Reasoned Document

S. No.	Clause No.	Clause	Comments From Firms/Railways & PUs	Comments	RDSO's Remarks
1.	1.1.3	Train shall have a minimum of 16 (sixteen) passenger carrying Cars. Minimum length of the train shall be 384 (three hundred eighty-four) meters, buffer to buffer. The maximum train length shall not exceed that of the longest passenger train operating on the Route of the Railway Network. For the avoidance of doubt, a Car having Driving Cab and also carrying the passengers shall be considered as a passenger carrying Car	M/s Patentes Talgo SLU	Could you inform us about the longest passenger trains that are operating in every route?	Presently, maximum 24 coaches having 24-meter length each, hauled by locomotive are permitted in IR for passenger services.
			M/s BT	<p>BT Clarification: Requirement of train flexibility missing.</p> <p>BT Proposal: We understand that the requirements in the specification are linked to the described 16 car configuration. Therefore, we would like to understand the performance requirements for longer configurations up to the maximum expected train length. We understand the maximum train length has to be equal to 24 coach configuration similar to ex

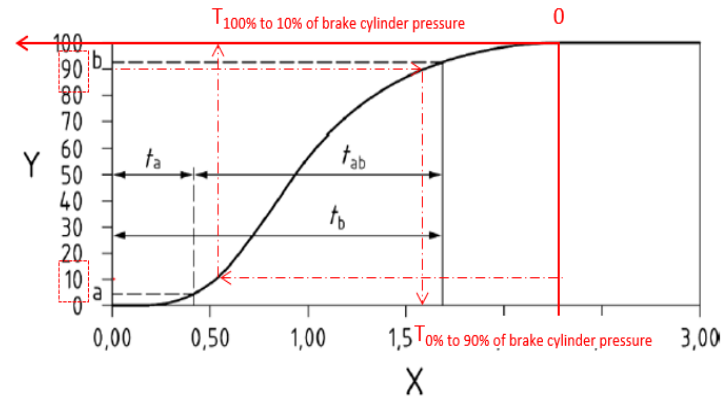
(i) It must be clarified if the requirement 3.42.11.1 related to brake Operating Timing is well written, since it seems to refer to the times defined in the standard EN 14531-1 as system response times. Please confirm . the Graph to help the understanding of the brake requirement is presented in next cell for RDSO's reference .

(ii) The Timing for a brake application indicated in this requirement does not correspond to the current response times of an UIC-Type pneumatic brake.

The defined Timing requirement is more focused for commuter type trains, that is means, trains designed to run urban and suburban routes.; That kind of trains accelerates and braking continuously, the time between stops is very low.

For the long distance Trains that are being required for the PTO in which there are less number of stops and greater distances between stations, the adequate type of brake should be based on UIC brake Types, according to UIC 14198 y UIC 544-1.

Then we propose the following change in order to align the requirement with the UIC brake achievable performance:

42.	3.42.11	Brake Operating Timing 3.42.11.1 The following maximum brake operating timing shall be achieved on all Cars of a Train. The maximum time for a brake application from full application to 90% of full Brake Cylinder Pressure (BCP) and for brake release from full Brake Cylinder pressure to 10% shall not exceed the following: (i) Service Brake Application: 2.0 seconds (ii) Emergency Brake Application: 1.5 seconds (max.) (iii) Service and Emergency Brake Release: 2.5 seconds	M/s ALSTOM	The Brake Timings provided in clause 3.42.11.1, are more applicable with EP Brake system. Reference to clause 3.42.5, For Loco hauled Train with conventional brakes system (BP control) We Suggest to add alternate timing in line with UIC 547 as per Passenger mode "BC filling timing between 3 to 6 secs and BC Release timing between 15 to 20 secs".	Accepted, Para 3.42.11.1 has been modified as below:

As per scope of EN 14198 page 5

“ This standard defines the basic requirements for the braking of trains pulled by locomotive, including the requirements of their vehicles, running on European networks and their infrastructure systems”

Thus the comments of M/s Talgo to refer EN14198 is not acceptable.
